CH2M Response to Puerto Rico Coastal Zone Management Program Request For Additional Information for 404 Joint Application Permit for Outlet #1 and #2 at Area1, SWMU 3 on Naval Activity Puerto Rico, Ceiba, Puerto Rico

PROJECT: JM01 SWMU 3 Area 1 Outlet #1 and #2

CH2M Response to USACE Comments for 404 Joint Application Permit for Outlet #1 and #2 at Area1, SWMU 3 on Naval Activities Puerto Rico, Ceiba, Puerto Rico

CH2M Response to USACE Comments for 404 Joint Application Permit for Outlet #1 and #2 at Area 1, SWMU 3 on Naval Activity Puerto Rico, Ceiba, Puerto Rico

4 **SILT FENCE**
NTS

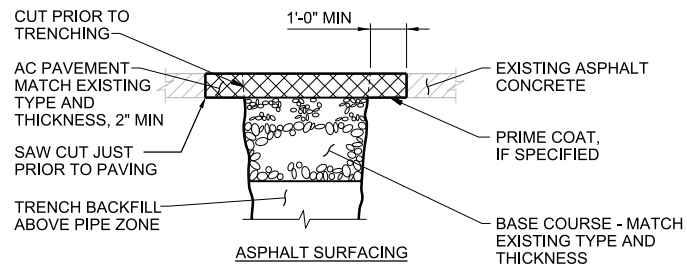
6. **Corps Letter Comment:** f. The proposed silt fence would impact waters of the U.S. based on Figure 4 and outlet #2 plan. Please provide a description of proposed fence, dimensions and construction method.

CH2M Response: *Silt fencing will constitute temporary fill in regulated waters. Silt fence will be installed by mechanical and/or manual means depending on work conditions (see attached Figure 4, Figure 5 and Detail 4 on Sheet C-10) and will be less than 3 feet beyond the construction footprint of the outlets. Silt fence will be installed 0.5 feet below the sea-floor in an anchor trench per Detail 4 on Sheet C-10. For Outlet #1 the silt fence dimensions will be approximately 26 feet wide by 23 feet long within jurisdictional waters. For Outlet #2 the silt fence dimensions will be approximately 24 feet wide by 18 feet long within jurisdictional waters. Excavated material will be reused as general fill within the permitted area of the Area 1 construction activities. The silt fencing will be removed at the completion of construction.*

6 **STRAIGHT CONCRETE ENDWALL**
NTS

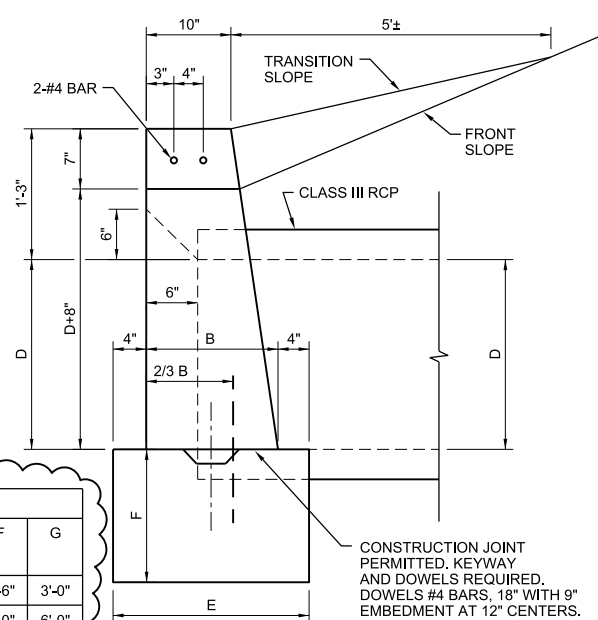
4. Corps Letter Comment: d. Provide additional information such as dimensions of proposed concrete outlet structures and rip-rap apron on outlet #1 and describe proposed work to install the proposed four pipes, gabions end wall and gabion mattress including dimensions. A description of construction method, indicating whether temporary fill is required on waters of the U.S. and the surface area (in acres) temporary impacted as well as indicate temporary disposal site for fill and/or dredged material. You stated that approximately 22 cubic yards of seafloor will be excavated, please provide a description of the excavation method, including the equipment to be used, indicate the excavated material disposal site, and the area of excavation in acres.

Concrete outlet structure – A concrete outlet structure will be installed that is 7.0 feet wide x 5.42 feet high x 2.17 feet deep at the base tapering to 0.83 feet at the top (see attached Detail 6 on Sheet C-10). Approximately, 1.5 feet of bottom portion of the concrete outlet structure will be constructed below grade for foundation purposes. None of the concrete outlet structure will be in jurisdictional waters.

**FIGURE 4
OUTLET #1
PLAN AND PROFILE
USACE 404 PERMIT**

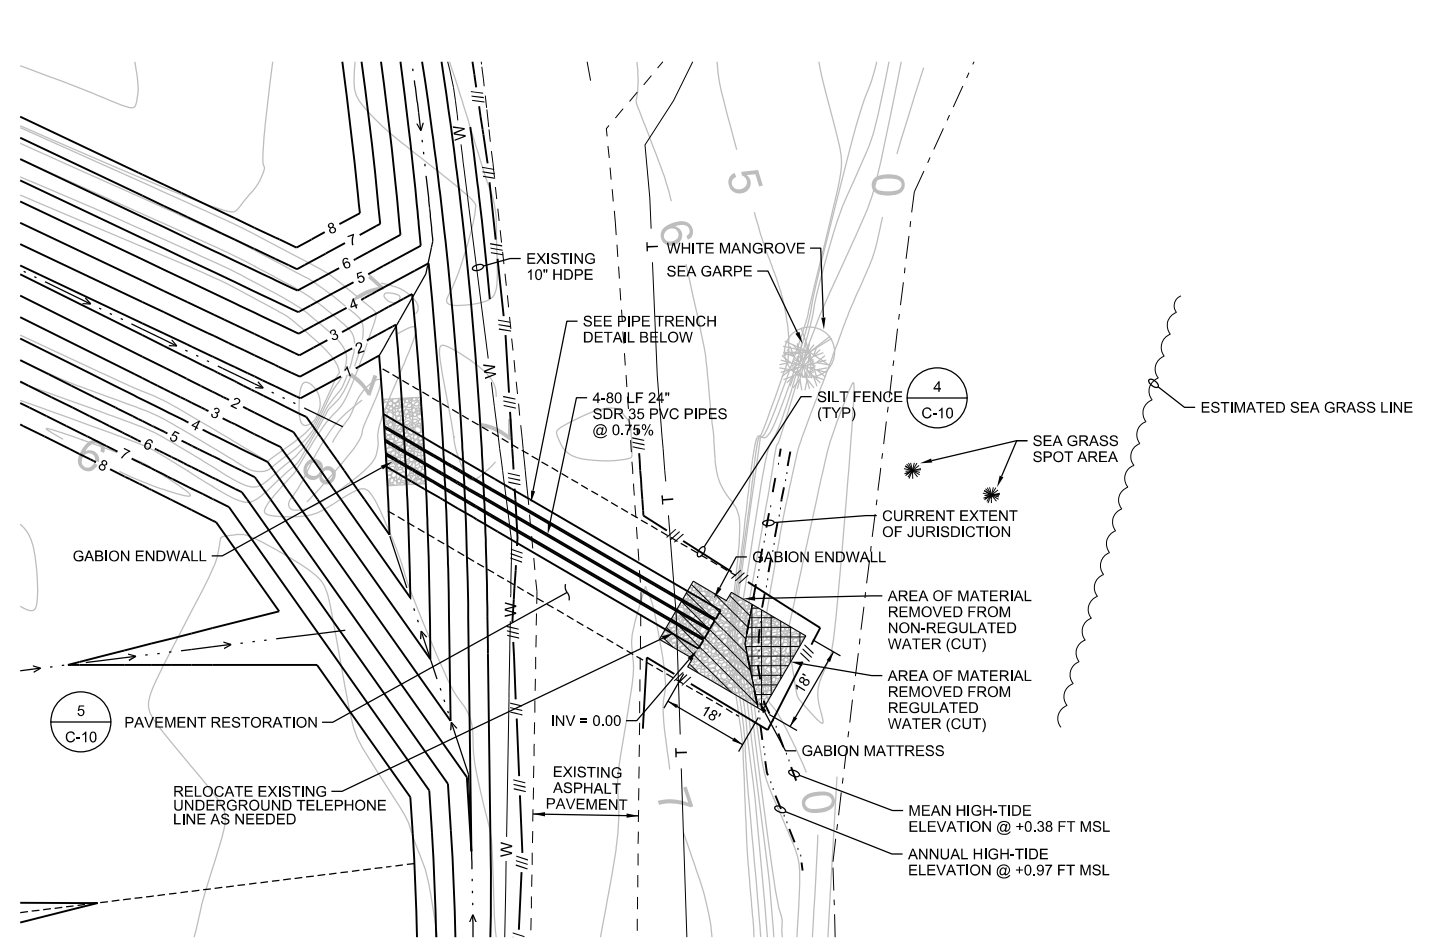
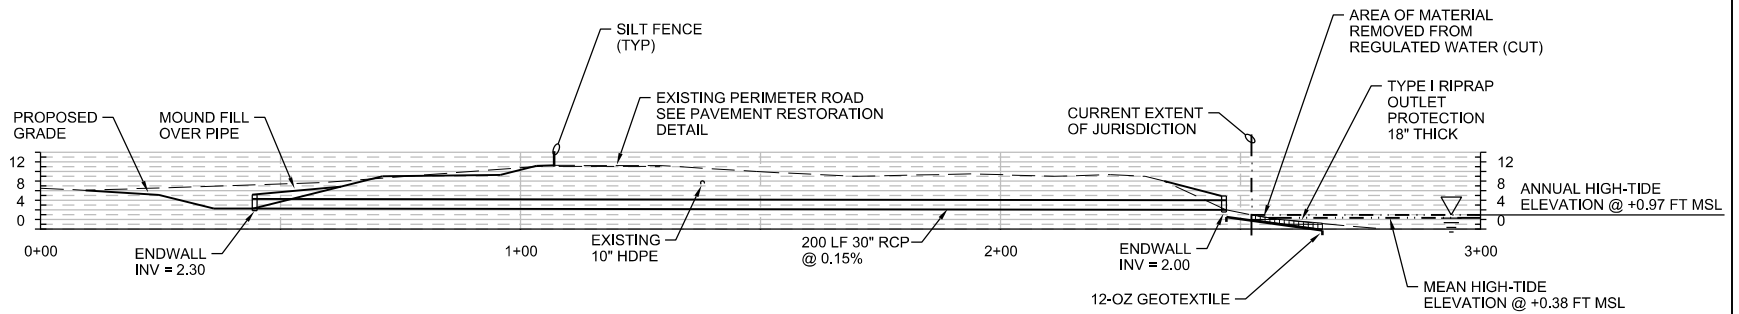
5. **Corps Letter Comment:** e. Revised plan view and cross-section drawings (Figures 4 and 5) and outlet #1 and #2 plans) showing both: the high tide and the mean high tide lines regarding proposed works.

CH2M Response: *Figure 4 (Outlet #1) and Figure 5 (Outlet #2) have been revised showing both the annual high tide and the mean high tide elevations.*

Figure 1
Maximum Potential Impact Area and Proposed Seagrass Relocation Area

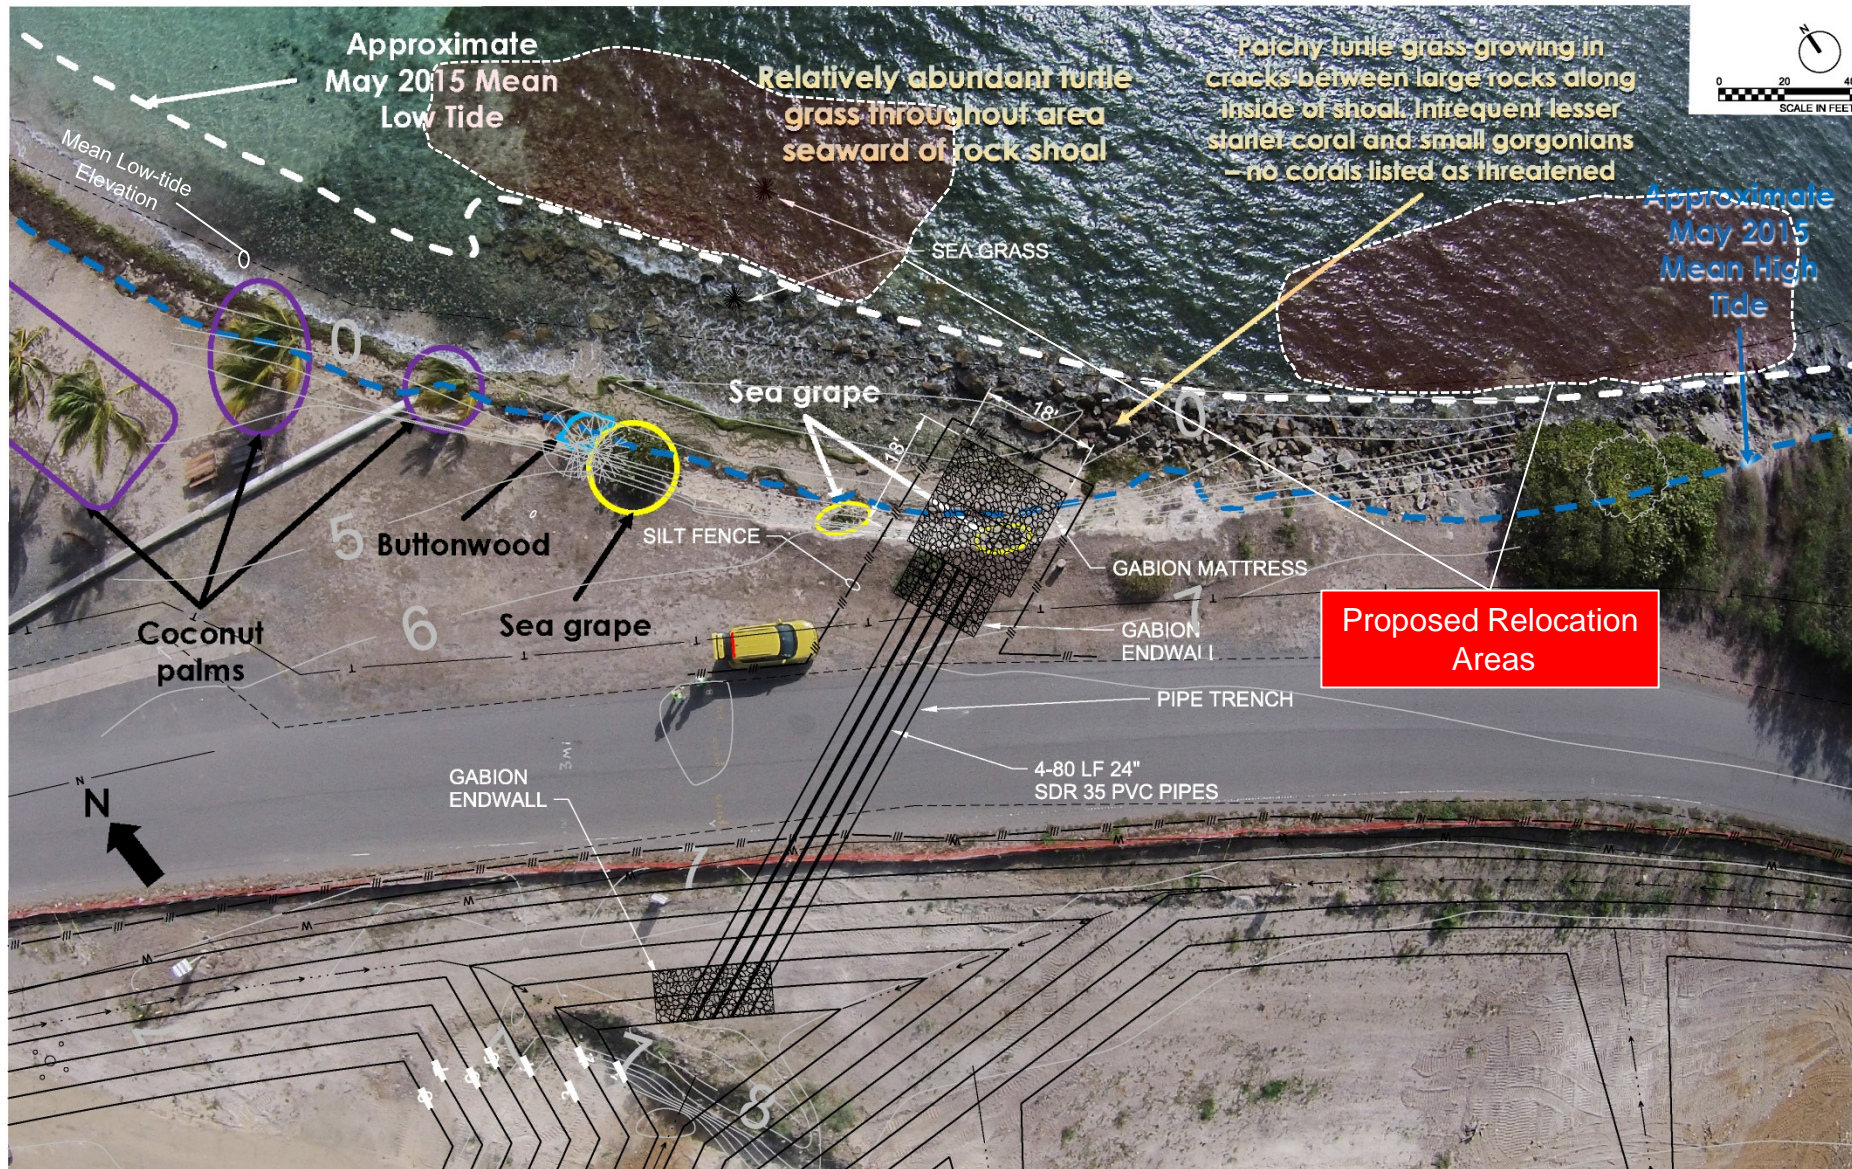
1. Corps Letter Comment: After reviewing the information submitted, we found that it still lacks of necessary information to accept your permit application as completed and continue with the review process for the reference project. Please furnish this office the following information:
 - a. For both proposed outlets, you stated that prior to excavation marine habitat (seagrasses and seafloor) will be relocated. Please show in the plan view drawing: the marine habitat areas to be relocated, indicate the amount (in acres) and show the relocation sites.

The maximum area of disturbance at Outlet 1, to include the full area enclosed by silt fencing below the high tide elevation, is 400 square feet. At the time of survey, no seagrass was within the proposed area of disturbance (See Figure 1). There is a small area of seagrass just beyond the area that would be encompassed by the silt fence, encompassing approximately 50 square feet but with less than 100% cover that likely would be within the freshwater halo effect area. This patchy seagrass would be relocated.

Because the growth of seagrasses is dynamic, it is possible that there would be seagrasses within the area of disturbance at the time the work is done. The maximum potential amount of seagrasses that would be relocated would be less than the 400 square feet within the disturbance area, as the area nearest the tide high tide elevation would not support seagrasses. It also is possible that the seagrass patch just outside the silt fence would be larger or smaller at the time the work is done. Based on the maximum disturbance footprint, the potential maximum area of seagrass that would be relocated at Outlet 1 is 0.001 ac (450 square feet).

Prior to commencing work, a seagrass survey will be completed and any seagrasses within the areas identified above would be relocated. The relocations would be to the immediately adjacent area, but more than 30 feet from the edge of the energy dissipation apron (see figure 1). Open areas within the existing seagrass bed in this area would be selected for relocation. A proposed relocation area is shown on the attached Outlet 1 Seagrass Relocation figure. However, depending on natural growth of seagrasses, this area may have to be moved laterally to reach a location with open patches at the time of work.

Figure 3

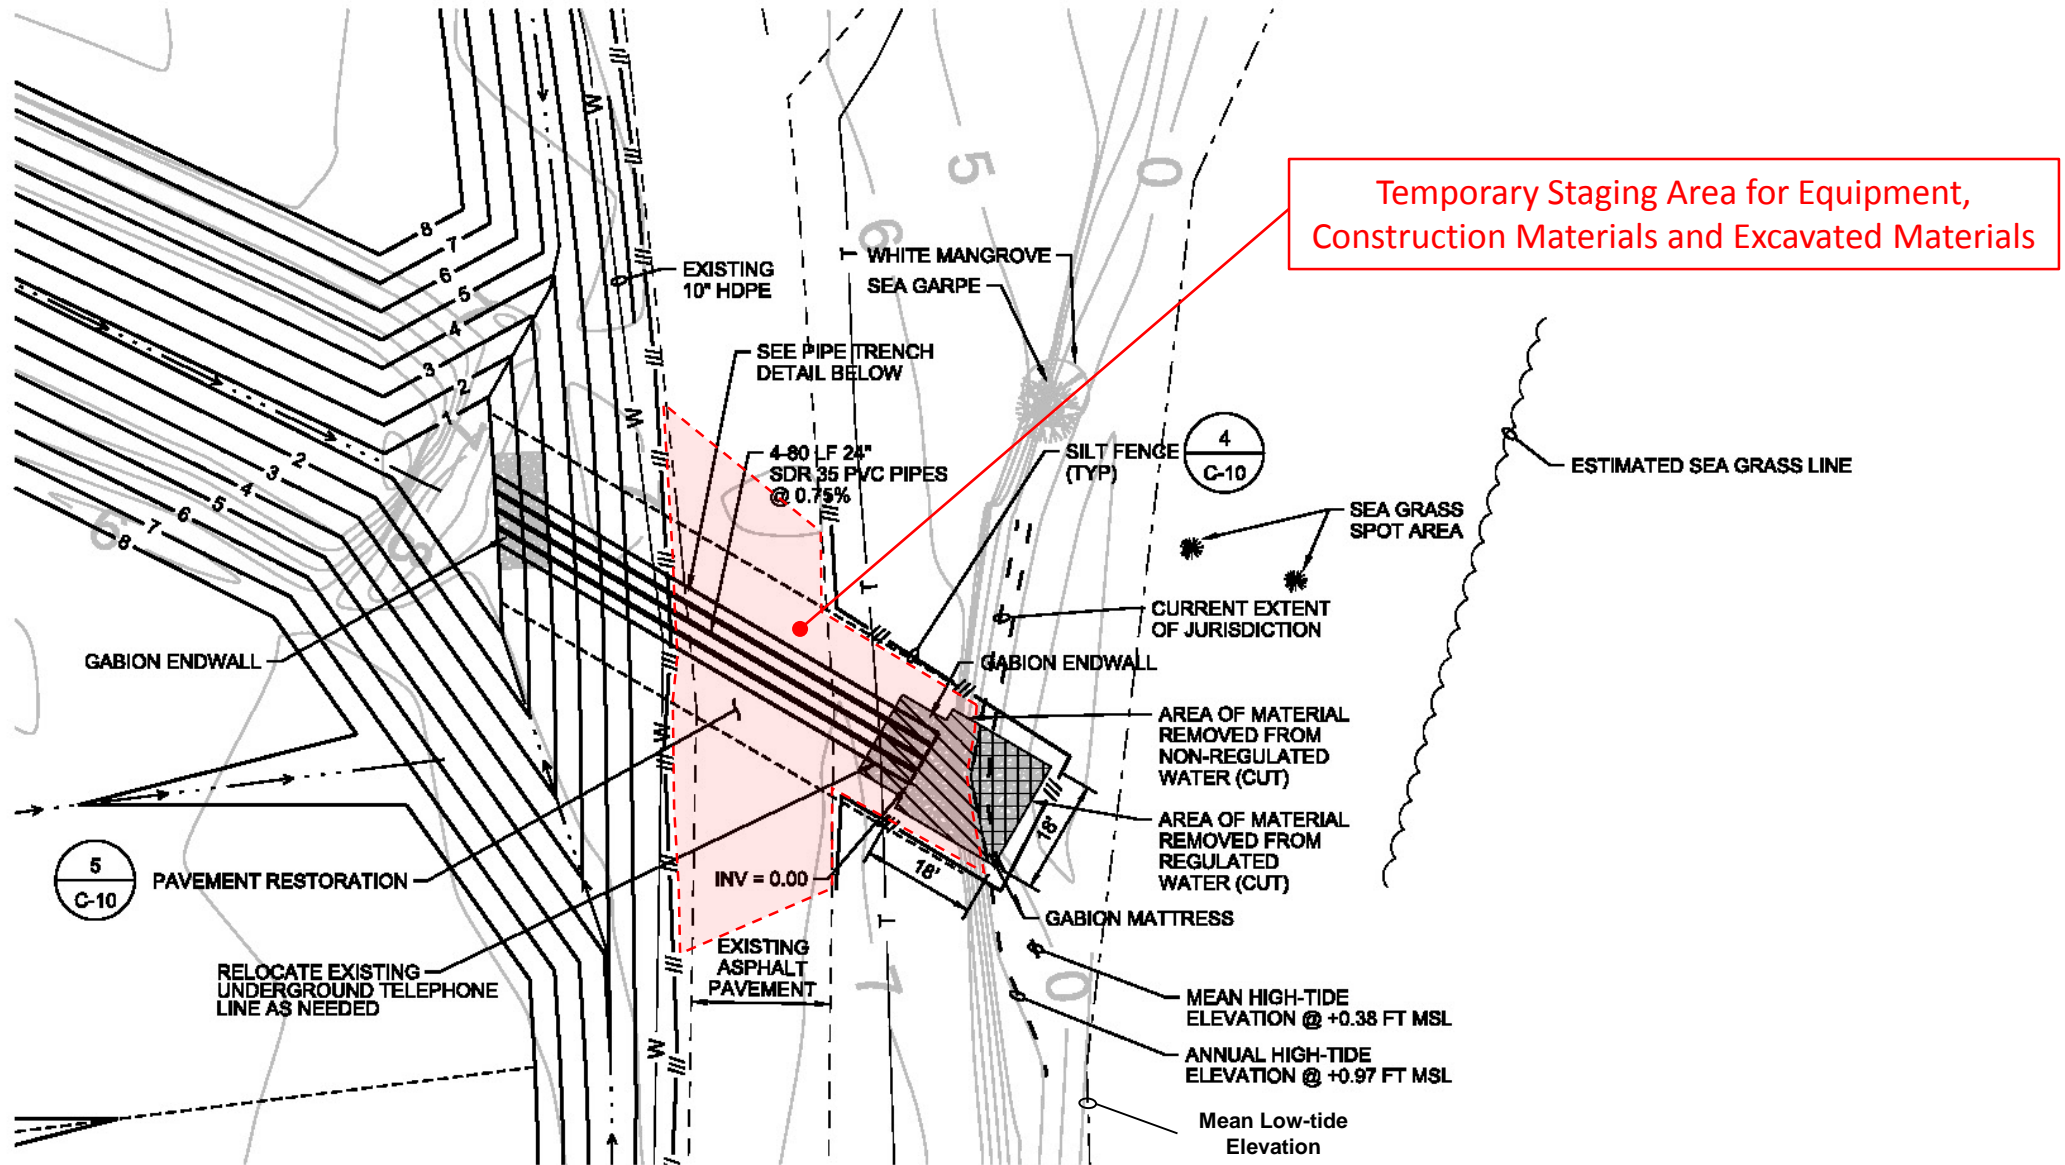
c. Provide a plan view drawing showing proposed location of staging areas to place equipment, construction materials, and excavated material.

CH2M Response: *Attached is Figure 3 for Outlet #1 and Figure 4 for Outlet #2 showing the temporary staging areas for equipment, construction materials and excavated material. These staging areas are within the authorized area for the landfill cap for SWMU 3. Permanent disposition of excavated material that is not reused in the excavation will be used a general fill within the Area 1 landfill footprint of SWMU 3. Area 1 has silt fence to prevent runoff from the landfill area and is in compliance with site E&SC BMPs.*
